Project	IEEE 802.16 Broadband Wireless Access Working Group < http://ieee802.org/16 >	
Title	Comments on AWD Idle Mode	
Date Submitted	2009-07-06	
Source(s)	Yih-Guang Jan, Yang-Han Lee, Hsien-Wei Tseng, Ming-Hsueh Chuang, <i>Jheng-Yao Lin</i> Tamkang University (TKU)	yihjan@yahoo.com
	Youn-Tai Lee, Chun-Yen Hsu Institute for Information Industry (III)	lyt@nmi.iii.org.tw
	Shiann-Tsong Sheu National Central University (NCU)	stsheu@ce.ncu.edu.tw
	Whai-En Chen National Ilan University (NIU)	wechen@niu.edu.tw
Re:	802.16m amendment working document "Comments on AWD 15.2.17 Idle Mode"	
Abstract	Comments on AWD Idle Mode	
Purpose	To be discussed and adopted by TGM for the 802.16m AWD.	
Notice	<i>This document does not represent the agreed views of the IEEE 802.16 Working Group or any of its subgroups. It represents only the views of the participants listed in the "Source(s)" field above. It is offered as a basis for discussion. It is not binding on the contributor(s), who reserve(s) the right to add, amend or withdraw material contained herein.</i>

Comments on AWD Idle Mode

Figure 417—Procedures during AMS **initiates** idle mode entry

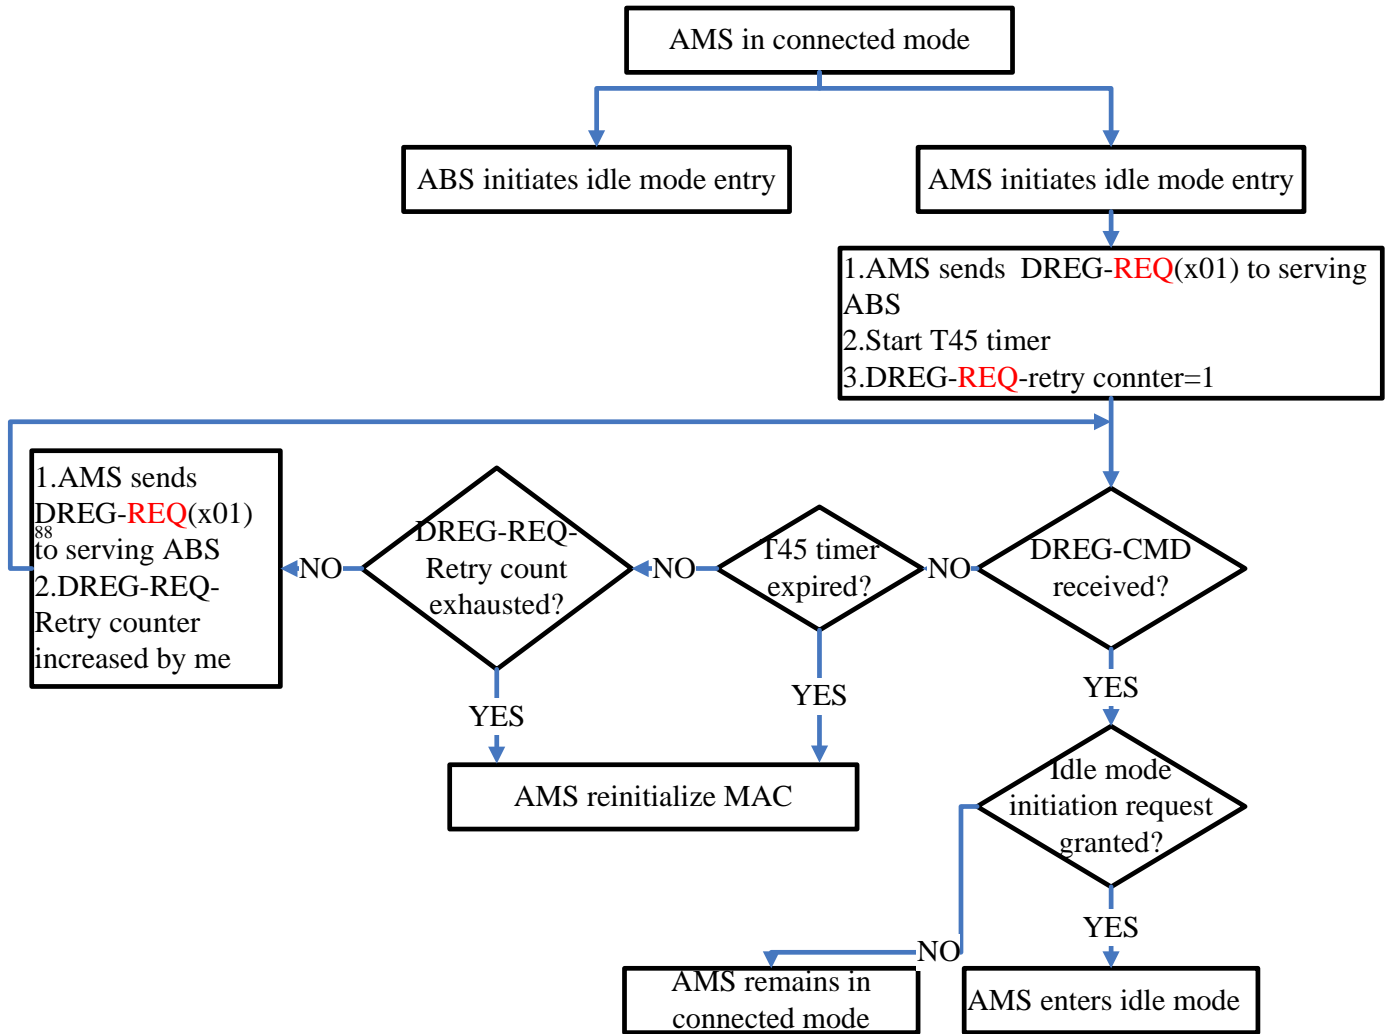
This contribution provides the corrected AWD text proposal to AMS initiates. In Figure 417, it has some errors in the functional blocks and needs correction.

[In IEEE 80216m-08_0010r2, Section 15.2.17.1.1, replace the original Figure 417 by the following corrected figure.]
